# SNDR and SNR\_ISI

Alexander Rysin and Piers Dawe

# Introduction

# Results

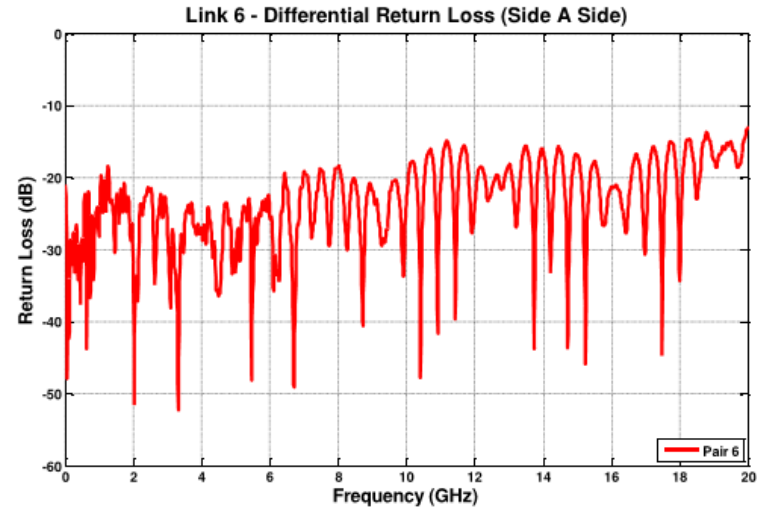
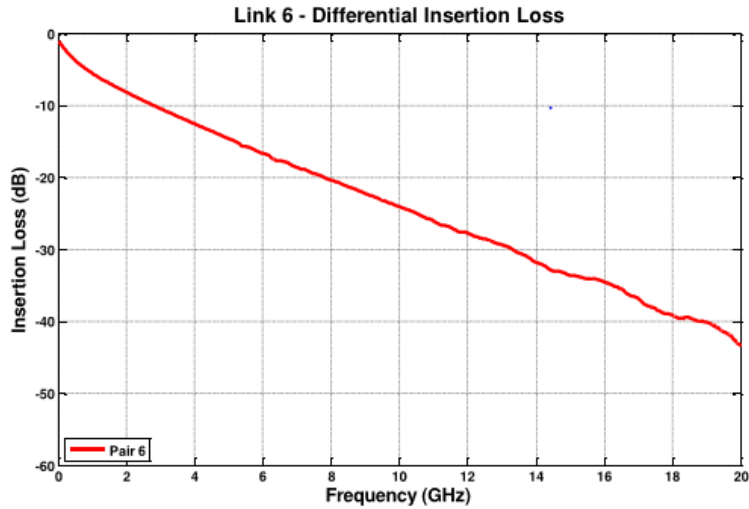
Initial settings		Step 1: Change SNR_TX from 32.5 dB to 29 dB		Step 2: <ul style="list-style-type: none"> <li>• Change Nb from 10 to 14</li> <li>• Change b_max[1] from 0.7 to 0.9</li> <li>• Change b_max[2...N] from 0.2 to 0.4</li> <li>• Change Cd from 180 fF to 160 fF</li> </ul>	
Channel	IL [dB]	Case 1 COM	Case 2 COM	Case 1 COM	Case 2 COM	Case 1 COM	Case 2 COM
Amphenol Link 6	30.1	3.401	2.987	2.592	2.236	2.757	2.372
Cavium HighZ	30.8	4.041	3.185	3.123	2.418	3.248	2.569
Cavium HighZ_Nom_HighZ	30.8	4.11	3.198	3.185	2.43	3.324	2.522
						Reducing the COM limit for the channel from 3 dB to 2.5 dB seems be more effective than step 2, and simpler
